### Site Plan Review

City of Rochester Hills  
Planning & Economic Development

Conditions and mark-ups noted throughout the plan set must be addressed prior to final approval.

**GATEWAY OF ROCHESTER HILLS**  
PART OF THE SOUTHEAST 1/4 OF SECTION 34, TOWN 3 NORTH, RANGE 11 EAST, CITY OF ROCHESTER HILLS, OAKLAND COUNTY, MICHIGAN

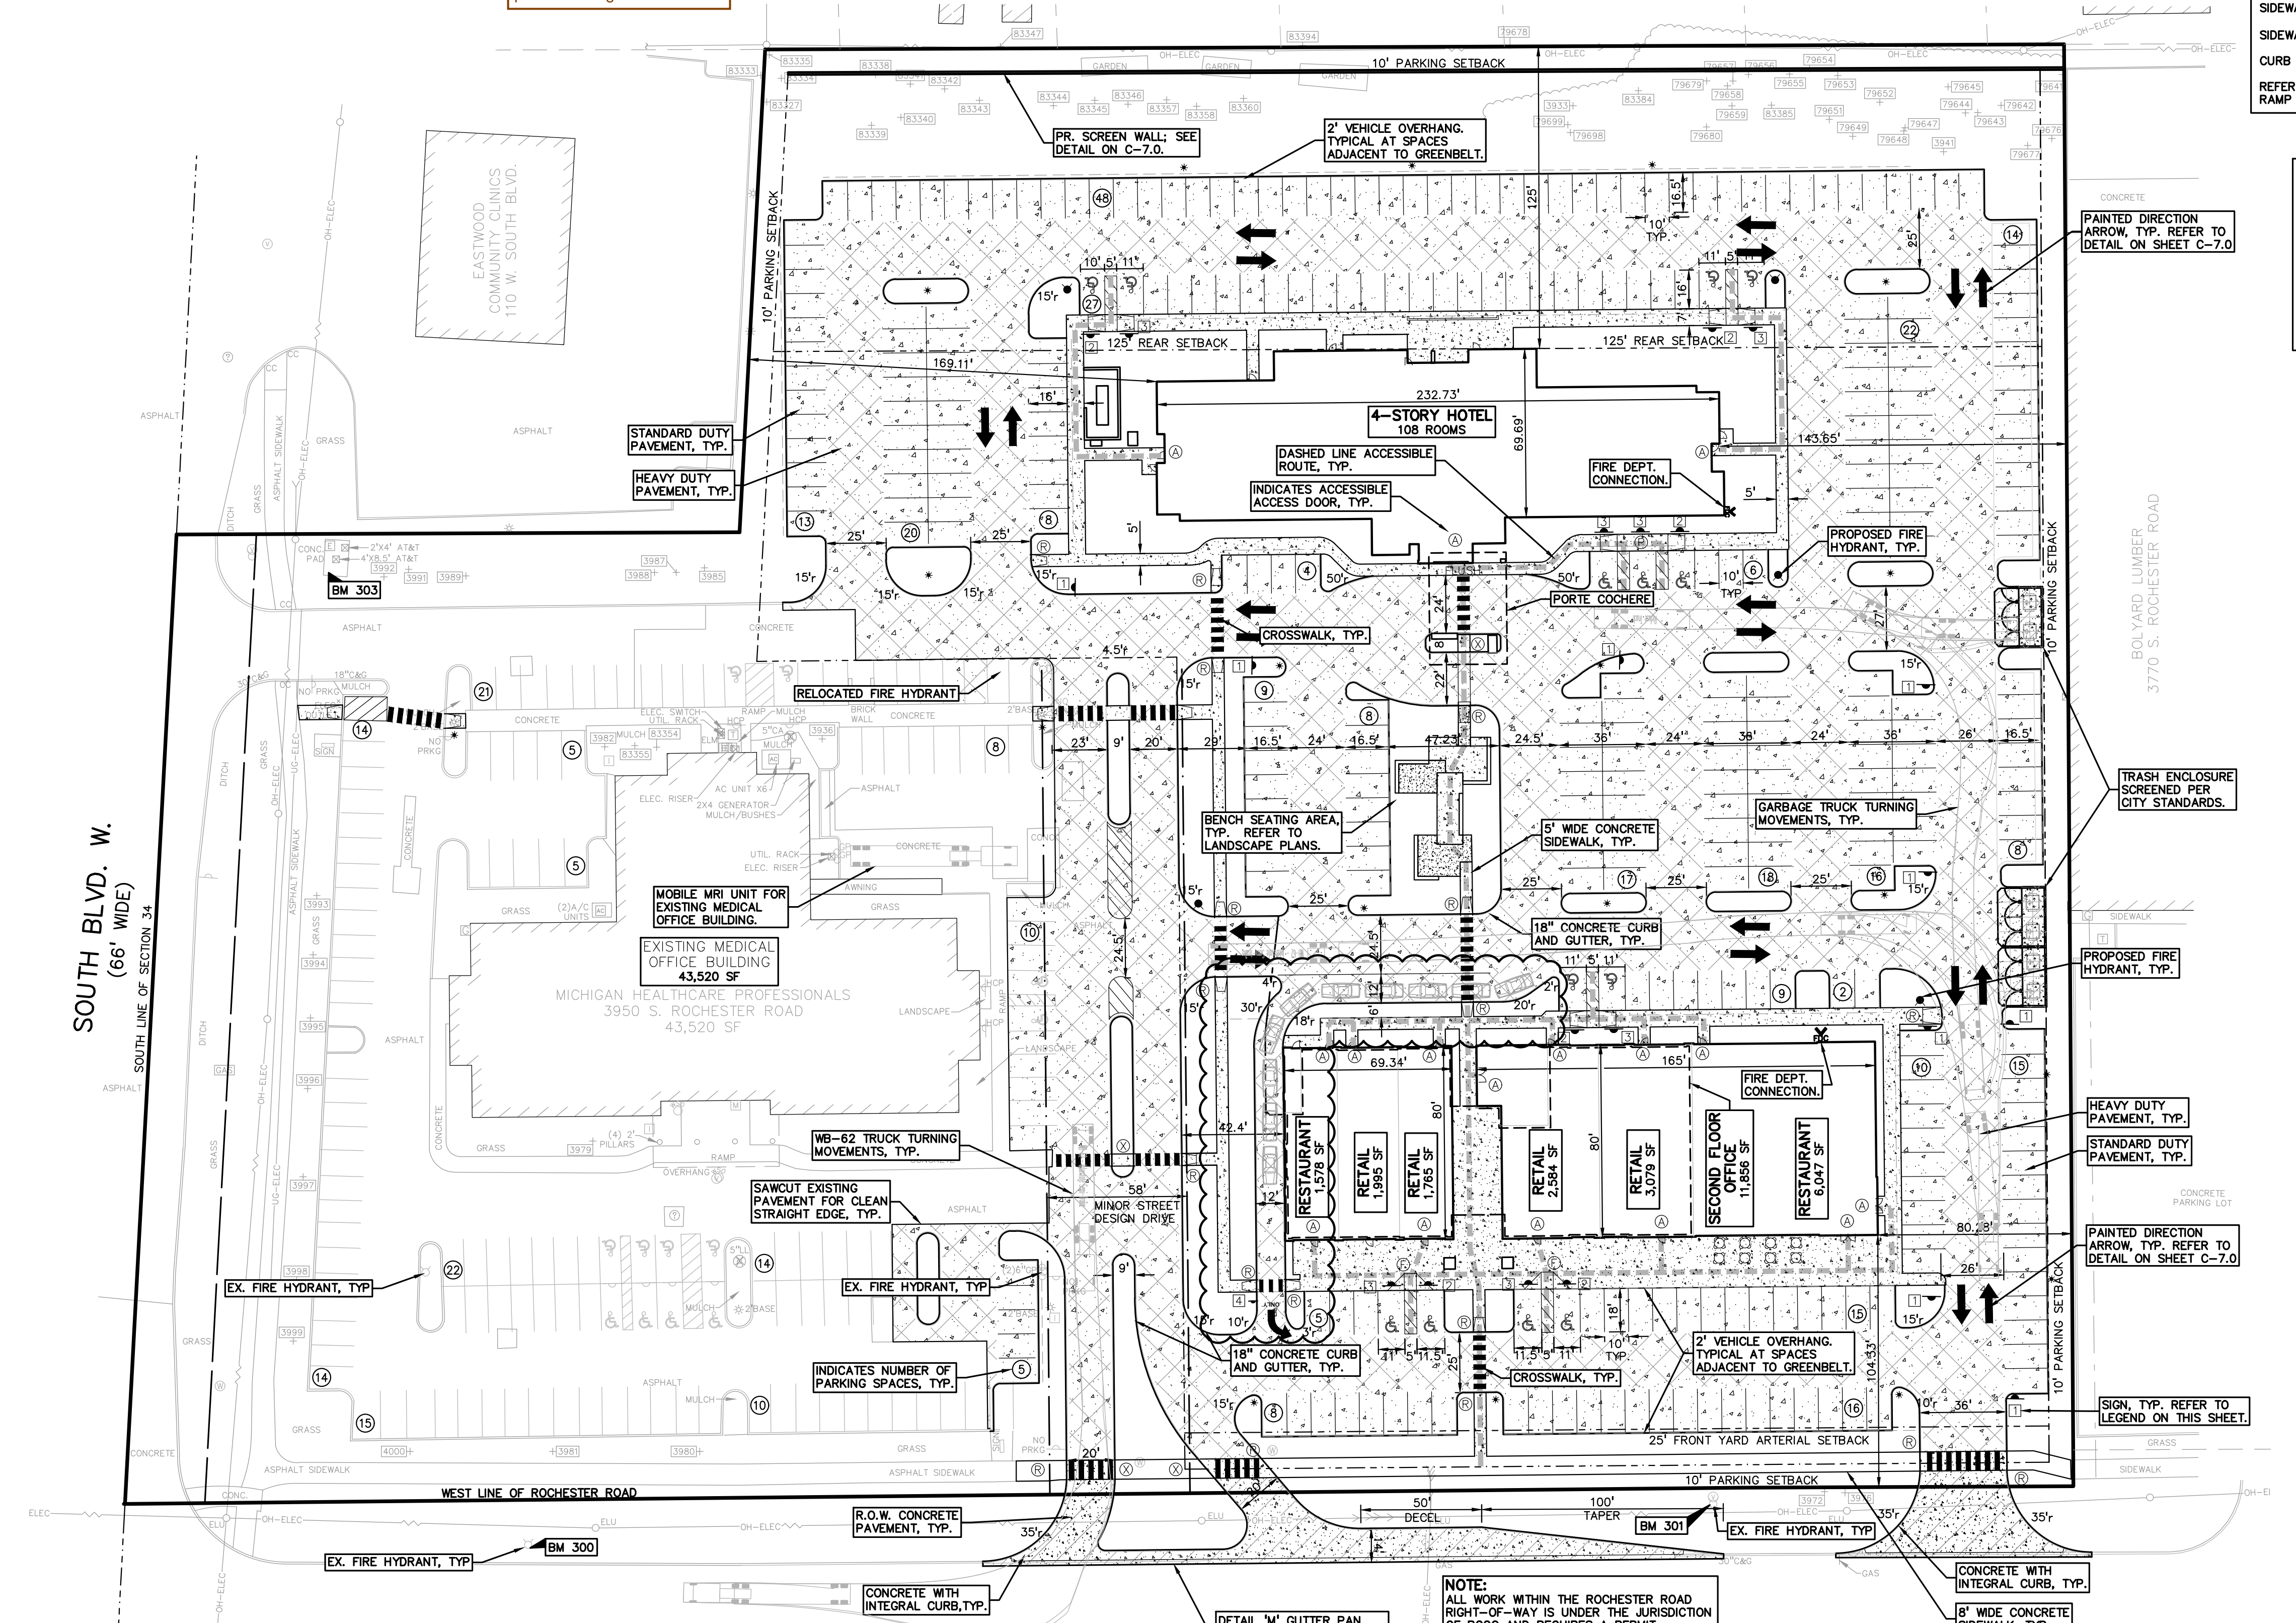
A conditional use permit is required for the proposed drive-through. Refer to Section 138-1.203 of the Zoning Ordinance for required signage that must be placed on the property 15 calendar days prior to the public hearing.

ORIGINAL ISSUE DATE: DECEMBER 14, 2017  
PEA JOB NO: 2017-237  
SCALE: 1" = 40'  
DRAWING NUMBER: C-6.0

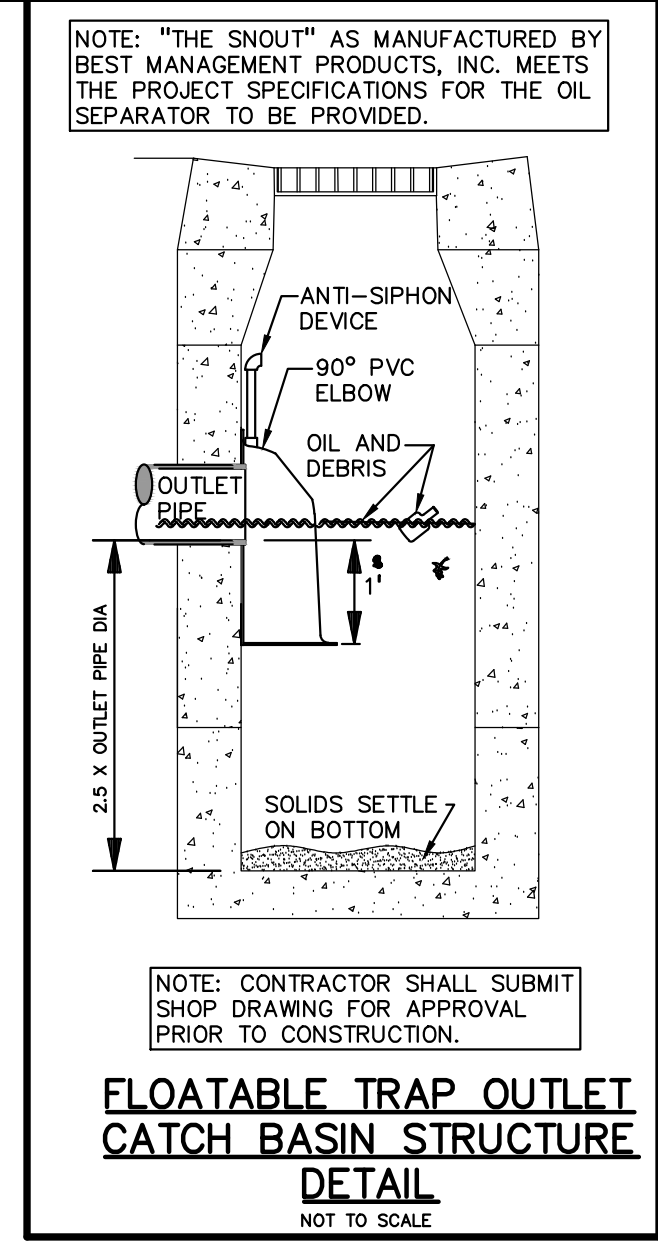
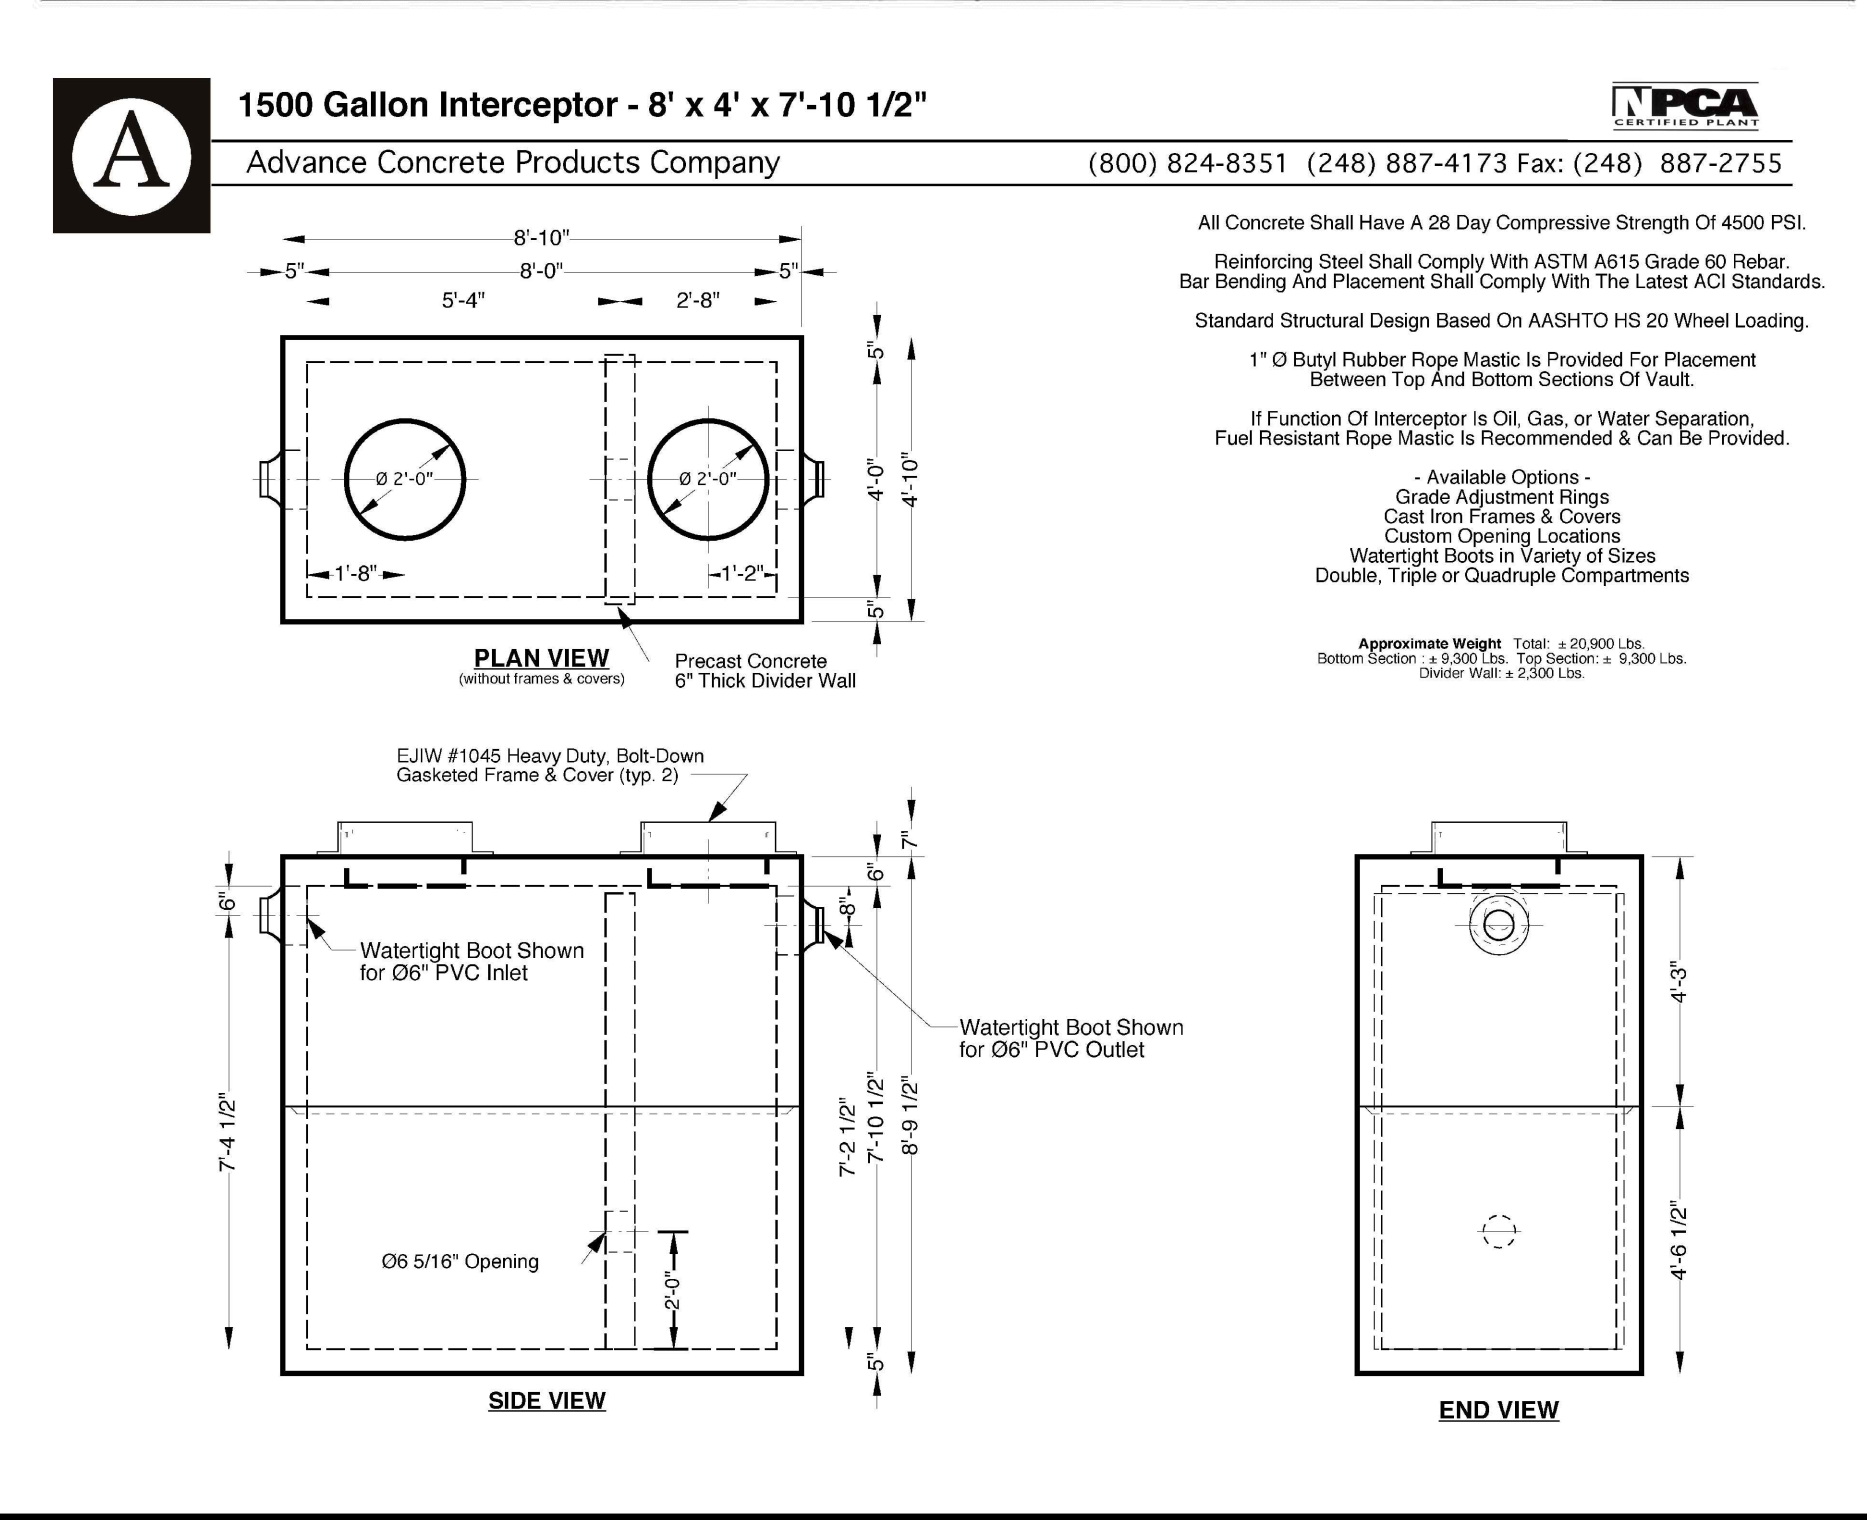
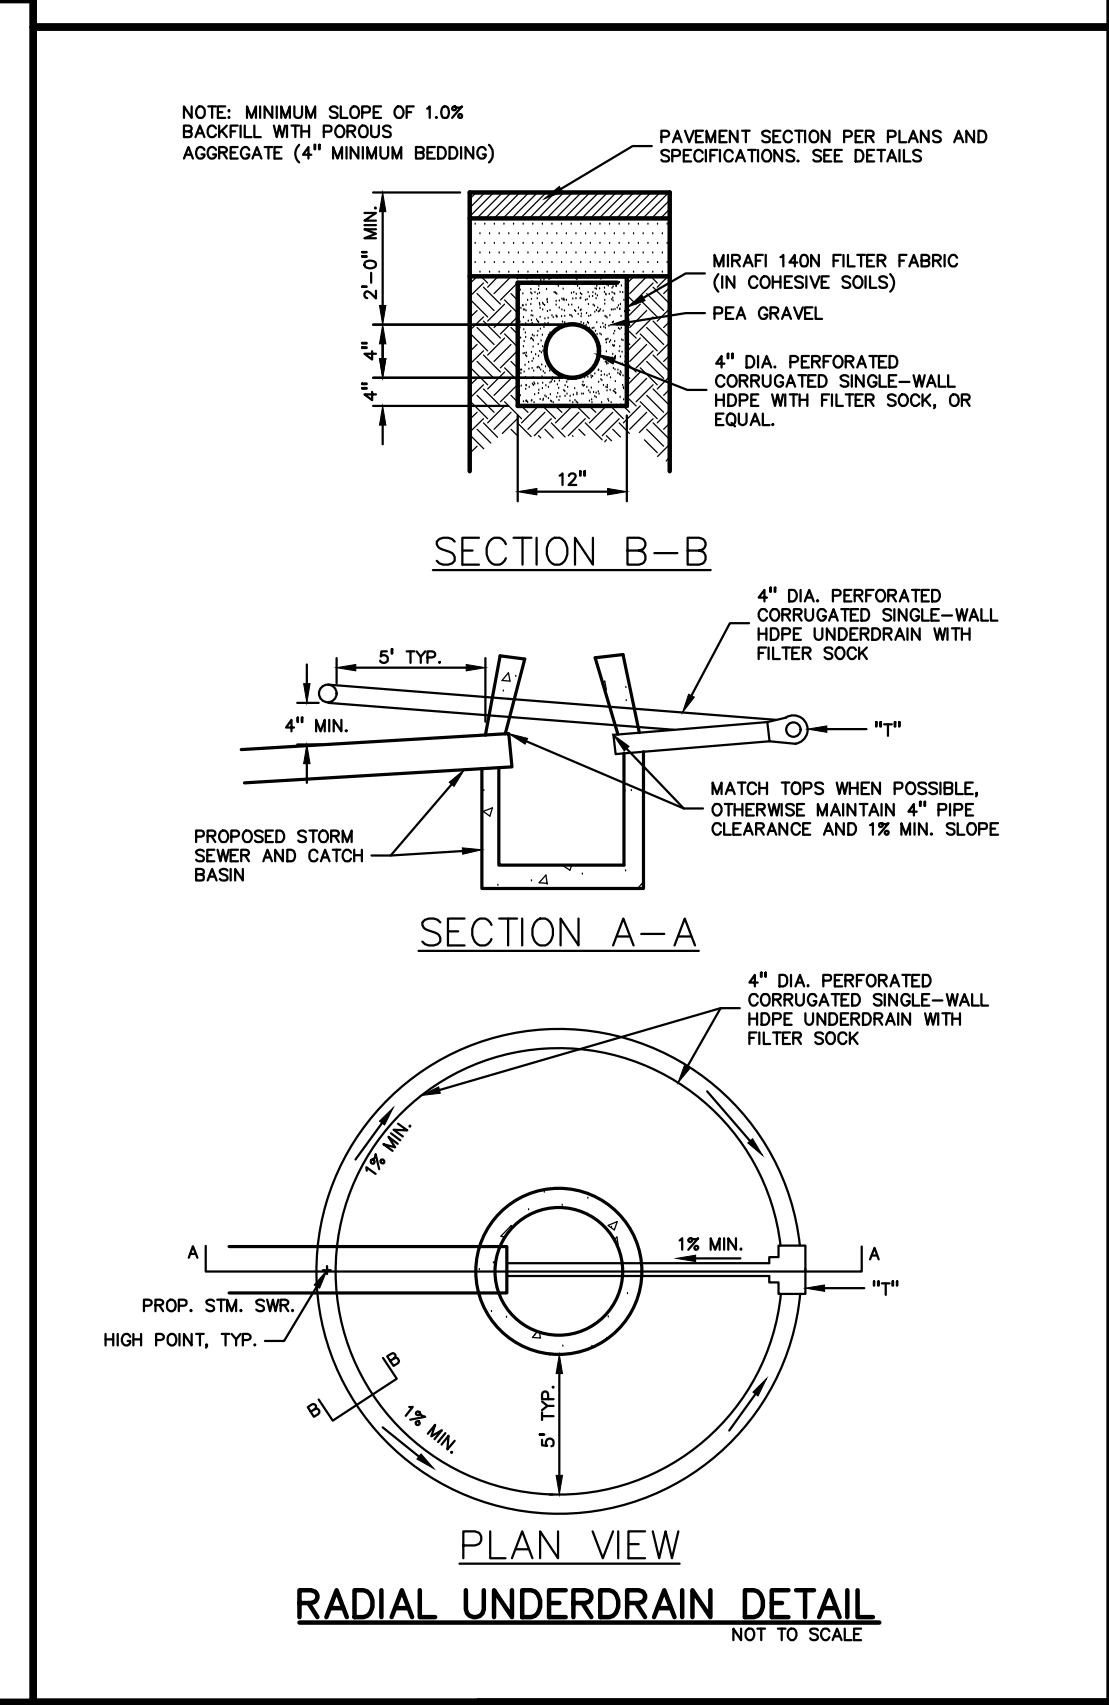
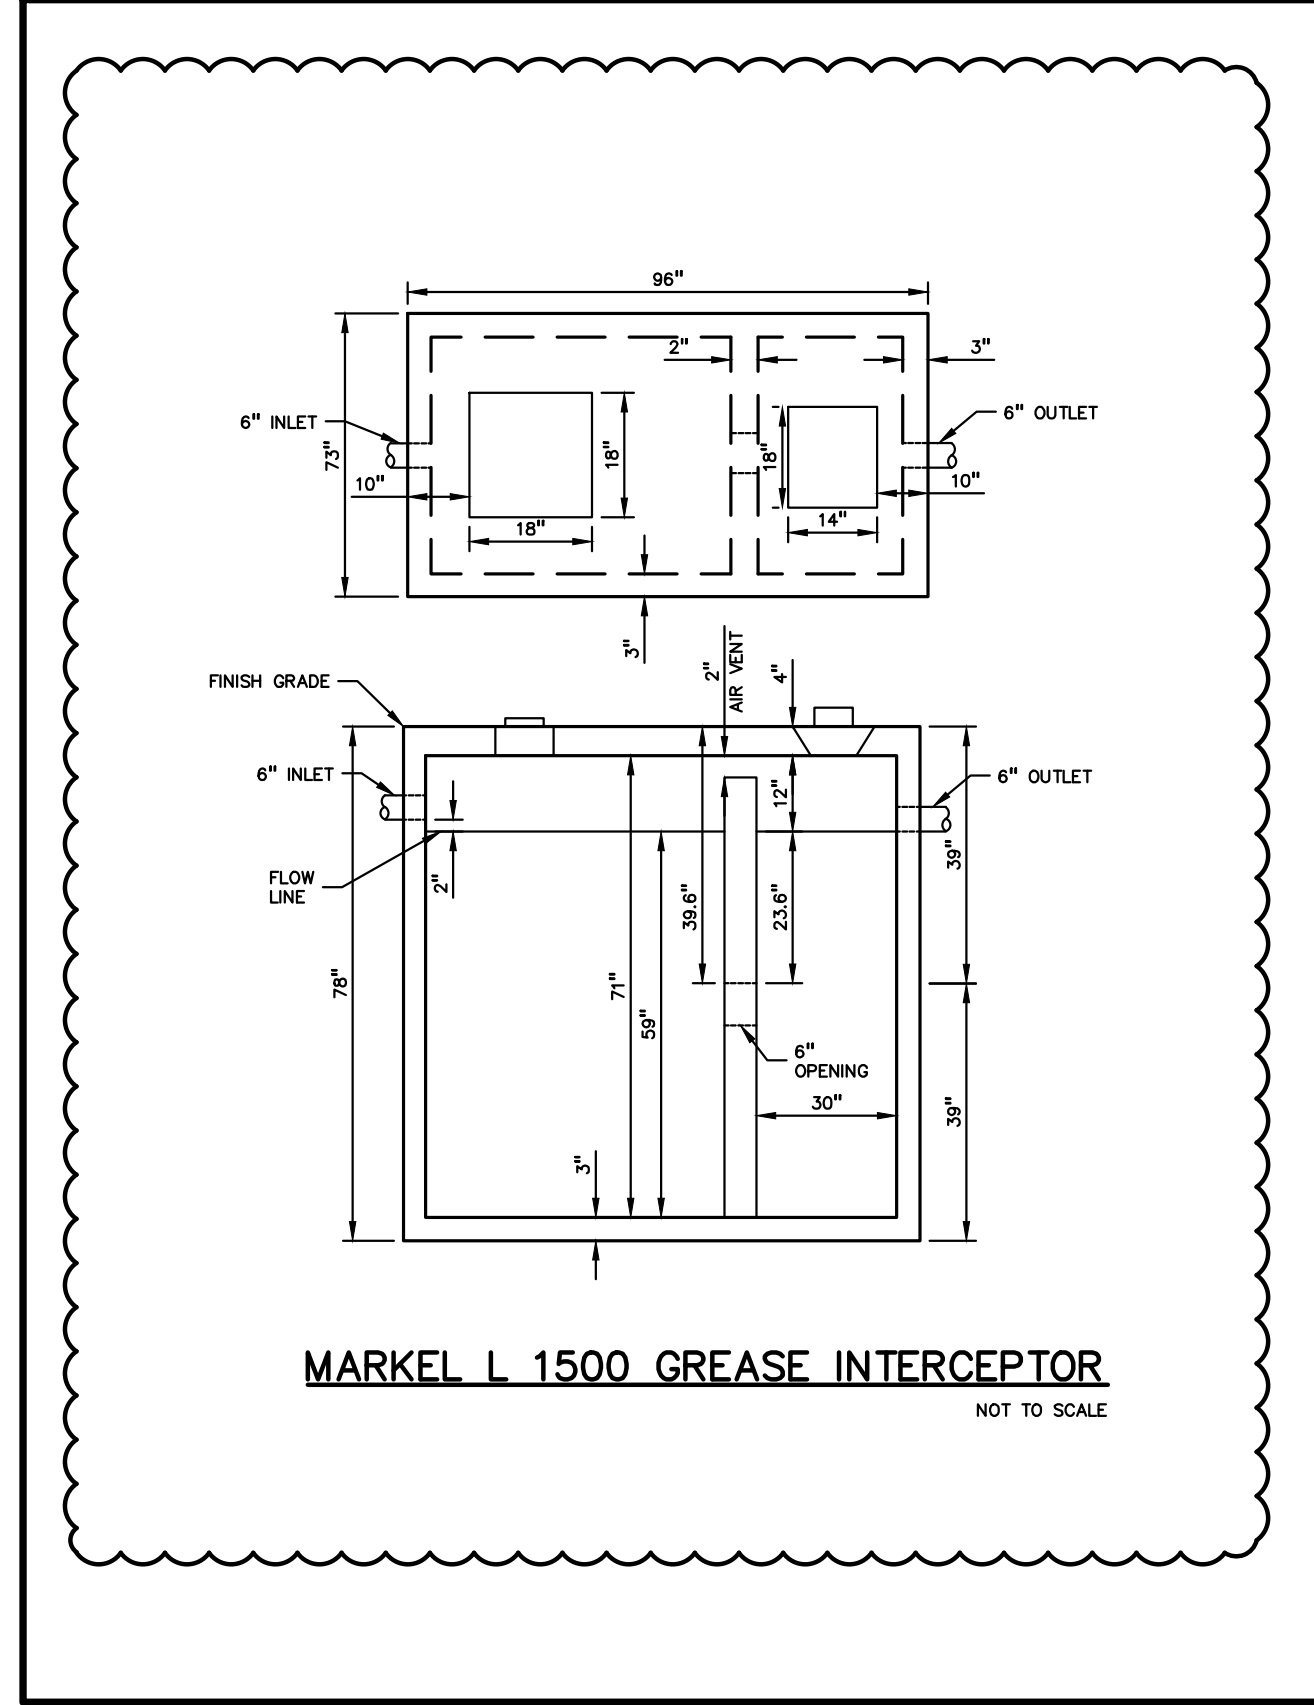
Revise to 95-044.3
